SUBJECT: Forwards marked-up Unit 2 Tech Spec pages, used to prepare draft Tech Specs for Unit 3. Advises that present Unit 3 schedule for fuel loading necessitates approval of Tech Specs by 870301.

Subject: Palo Verde Nuclear Generating Station (PVNGS)
Unit 3
Docket No. STN 50-530
Draft Technical Specifications
File: 86-F-005-419.05; 86-D-056-026

Enclosed are marked up PVNGS Unit 2 Technical Specification pages with justification, used to prepare the draft Unit 3 Technical Specifications. The changes presented herewith represent typo's, editorial comments, unit specific and technical changes to the Unit 2 Technical Specifications. The Unit 2 Technical Specifications that have not changed will be used as the basis for the remaining Unit 3 draft Technical Specifications as previously discussed with your staff.

Figure 6.2-1 and 6.2-2

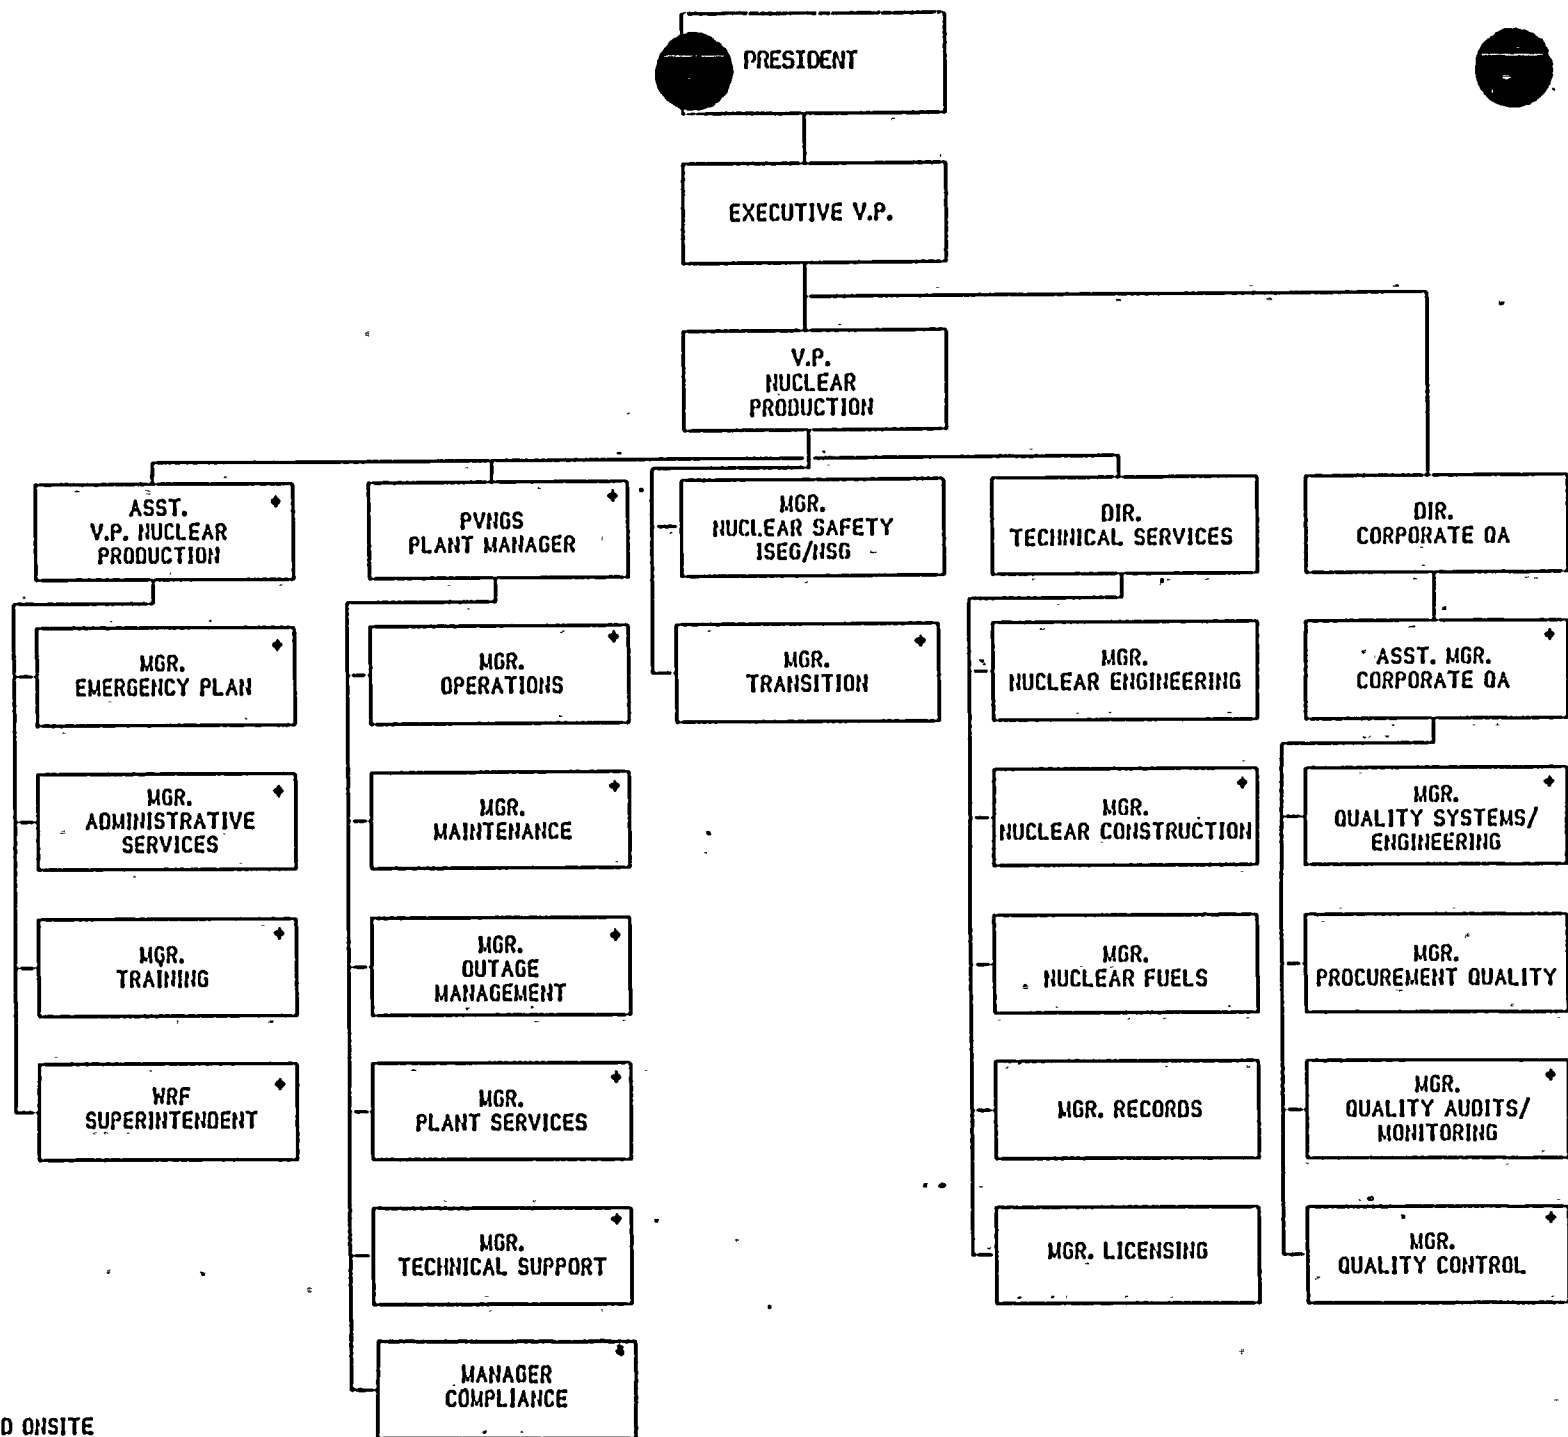
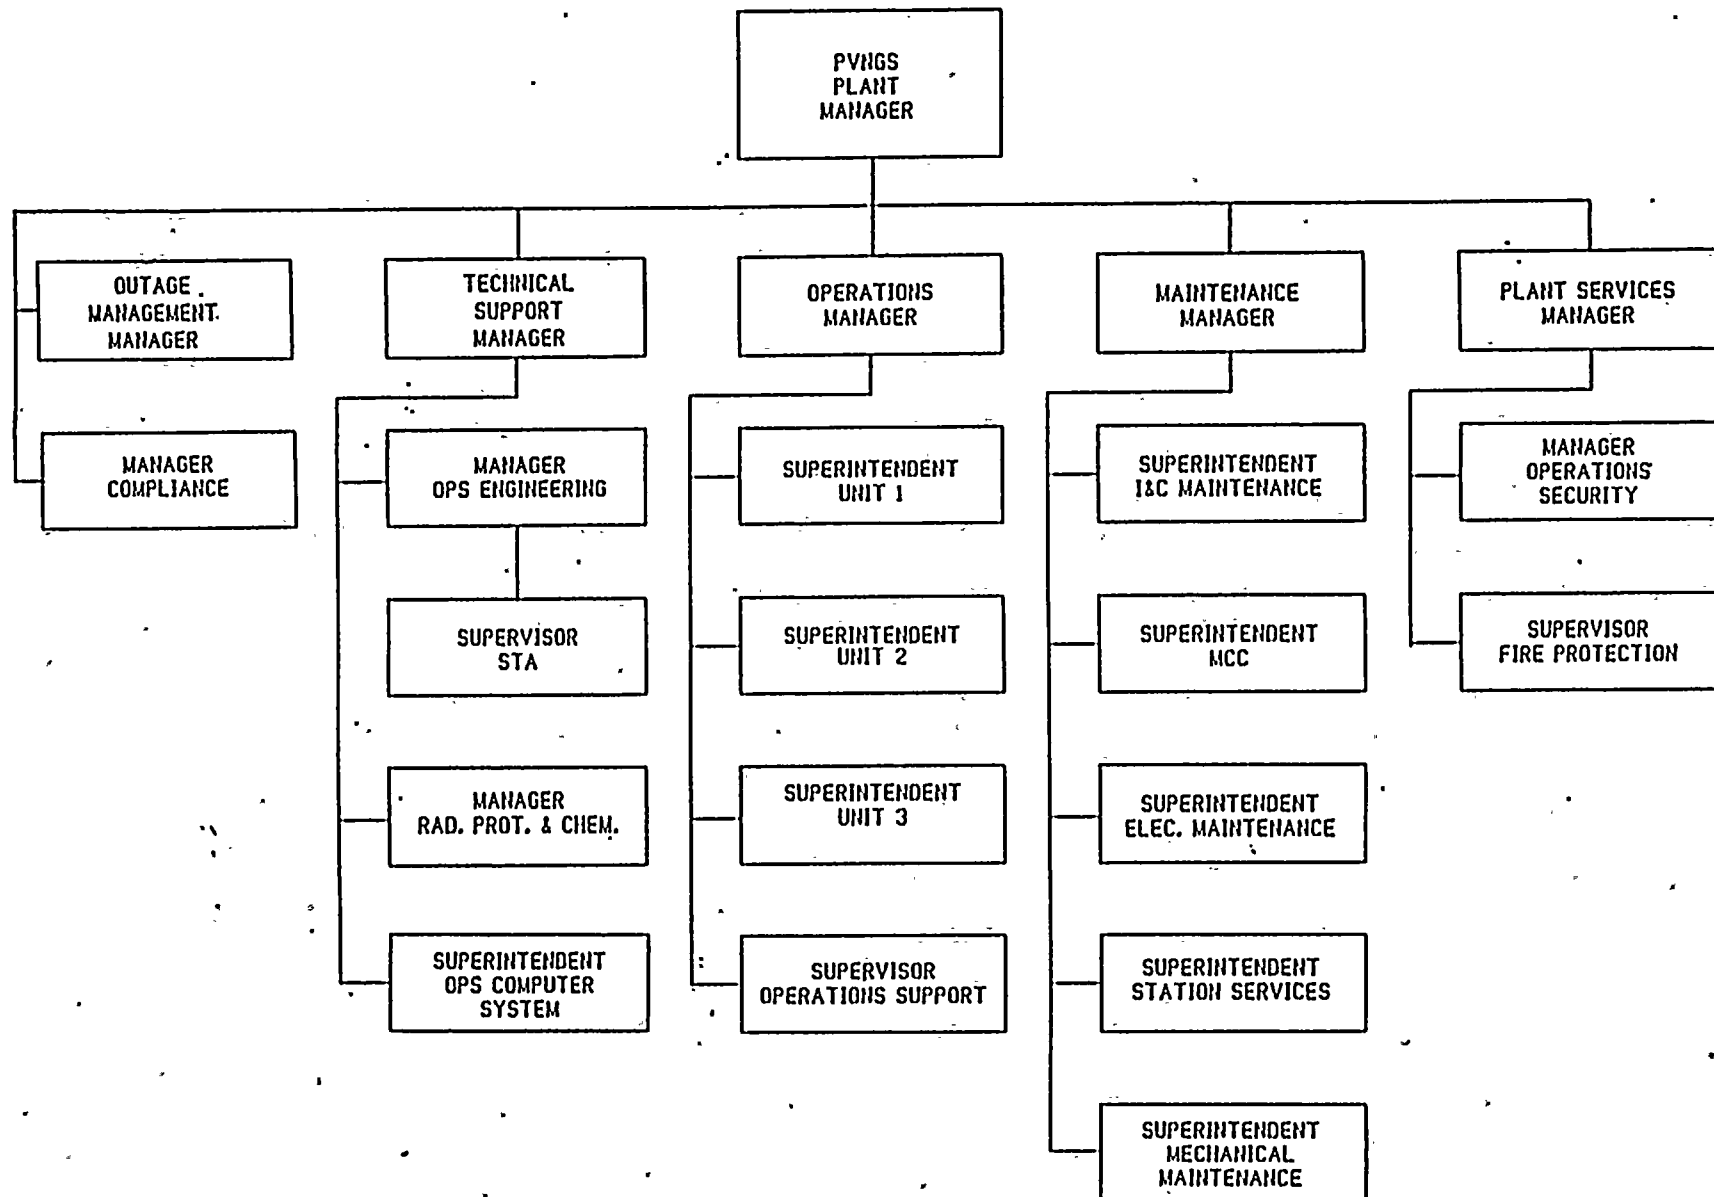
- 1) The changes to Figures 6.2-1 and 6.2-2 represent the current organization. The Executive Vice President of Arizona Nuclear Power Project will be reporting to the President and Chief Operating Officer of Arizona Public Service Co. Previously, the Executive Vice President reported directly to the Chief Executive Officer. This change was made because Palo Verde is shifting from its construction phase to its commercial operation phase.
- 2) Additional changes can also be seen on these figures in that; a) the Compliance Department will report to the Plant Manager. This change is intended to increase the effectiveness of Compliance in responding to regulatory and plant issues. And b), the title of Figures 6.2-2, has been changed from "ONSITE UNIT ORGANIZATION" to "ONSITE ORGANIZATION".
